THE REGIONAL MUNICIPALITY OF YORK

ADDENDUM # 4

BID # RFTC-1868-24-TR88179

FOR: Construction of Garage Expansion and Storm Water Management Pond at 3525 Baseline Road, Town of Georgina

Question 17:

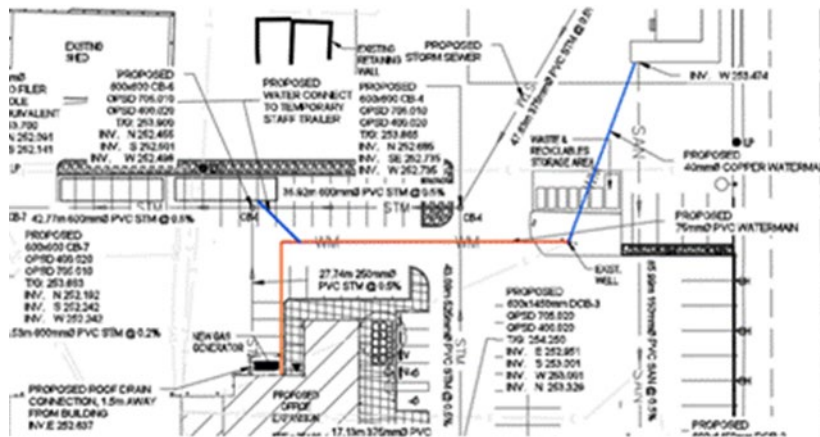
In Addendum #2, Questions 22 and Question 29 seem to contradict. Are there two different pipe sizes along the prop. watermain line or just one? Please Clarify.

There are two types of water lines:

Blue: 40mm diameter copper line running to the staff trailers

Orange: 75mm diameter PVC line running to the proposed building
